Rezoning Transportation Analysis

Petition Number: 2019-173

Date	Description
01-17-2020	First Review
05-20-2020	Second Review (WB)

SECTION B - B
PROPOSED ROAD IMPROVEMENTS
(FUTURE BY OTHERS)

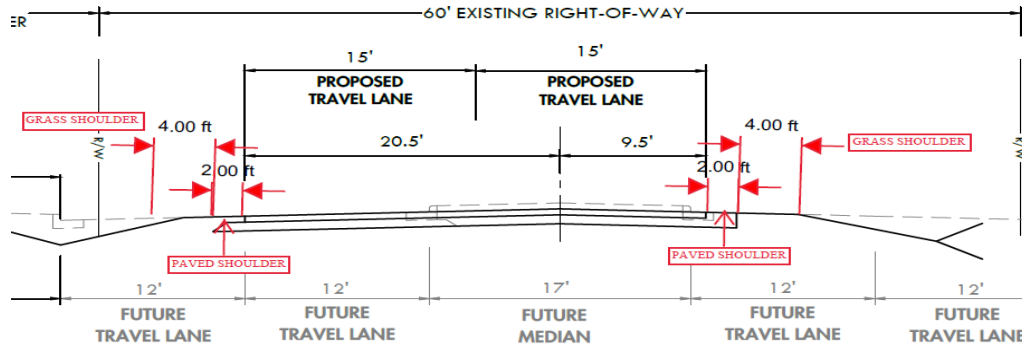
- New Comment based on revised site plan 05-11-2020:** The petitioner should revise the site plan and conditional notes to commit to construct 2-12' lanes with 2' paved shoulders and 4' grass shoulders for Section B-B. The petitioner should add a note stating the final details will be determined during permit review process to include input from other departments including but not limited to CDOT, General Services, Charlotte Fire Department, the NCDOT. Also include that any applicable ordinance requirements in addition to what is shown on proposed cross-sections may be required

SECTION C - C
PROPOSED ROAD IMPROVEMENTS
(FUTURE BY OTHERS)

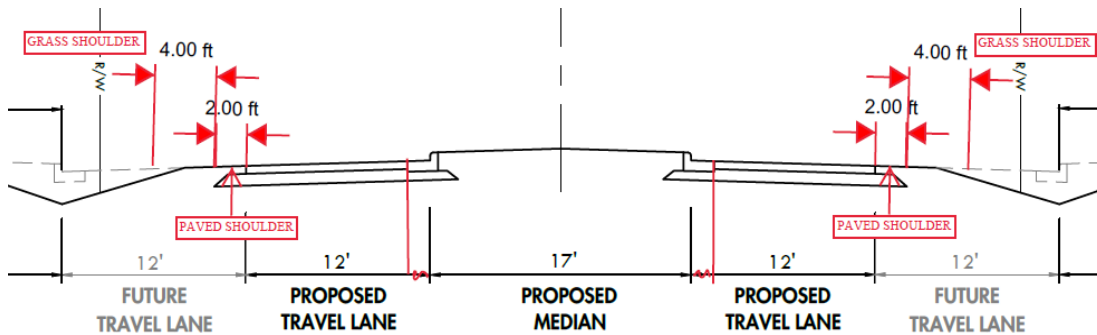
- New Comment based on revised site plan 05-11-2020:** Cross-section C-C depict the general intent of a 3-lane section (2 travel lanes and center turn lane and/or planted median) and a shared-use path for an interim version of future Garrison Road. The petitioner should revise the site plan and conditional notes to commit to construct 2' paved shoulders and 4' grass shoulders. The petitioner should add a note stating the final details will be determined during permit review process to include input from other departments including but not limited to CDOT, General Services, Charlotte Fire Department, the NCDOT. Also include that any applicable ordinance requirements in addition to what is shown on proposed cross-sections may be required.
